Filling the Virtualization Swamp (09-412v1)

October 1, 2009

Fabric Configuration Service (continued)

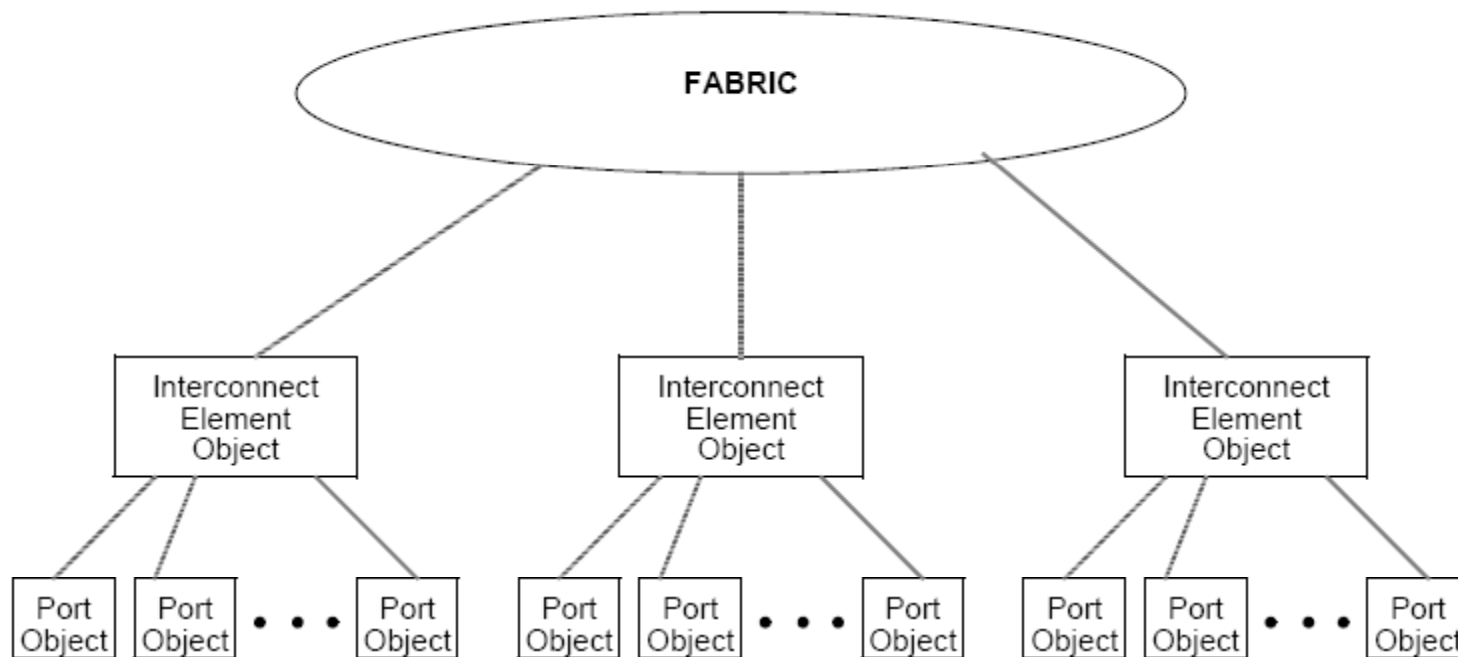
- Needs to be updated
 - What is meant by NxPorts outside of the physical fabric?
 - Description needs to be updated
- But what really is needed is ...
 - A complete update
 - To address FCoE, FCIP, and VF.
 - Thus it needs to address the idea there is a physical layer and a logical layer

- Interconnect Element and Port Attributes

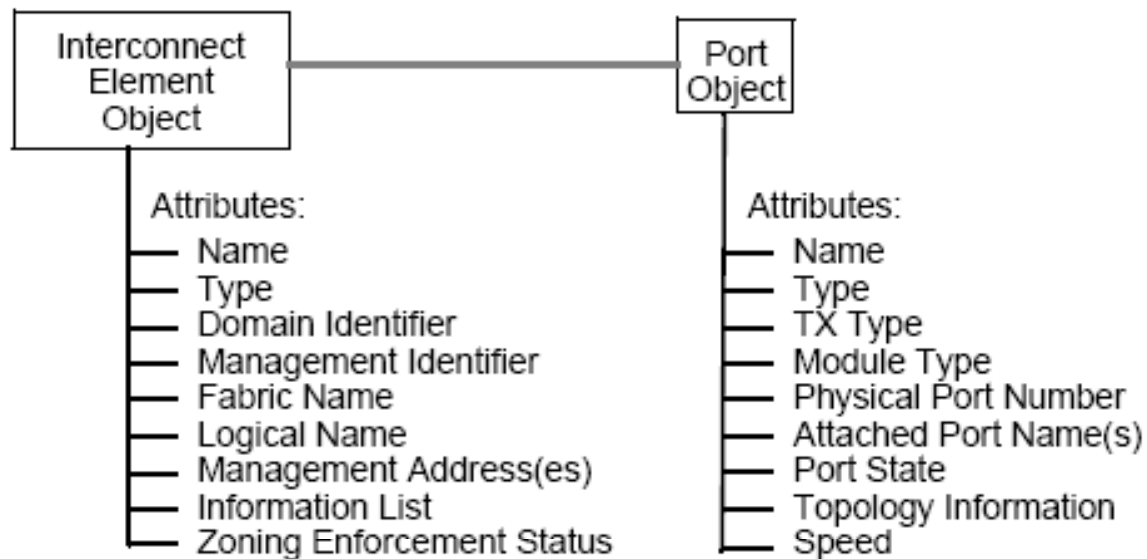
- Interconnect Element
 - One domain per Interconnect Element
 - Interconnect Element shown as a physical element
 - Interconnect Element Information List is vendor, product, version
 - Multiple domains in a single physical element
 - How do we handle this?
 - Directors are Switches, Bridges, and potentially Platforms (Virtualizer)
 - **Should Interconnect Element really be physical?**
 - **Do we need a new underlying object?**
 - How should a FCoE Switch be reported?
 - Switch, Hub, or Bridge
 - Implementations seem to be a Switch and a Bridge
 - New Type?
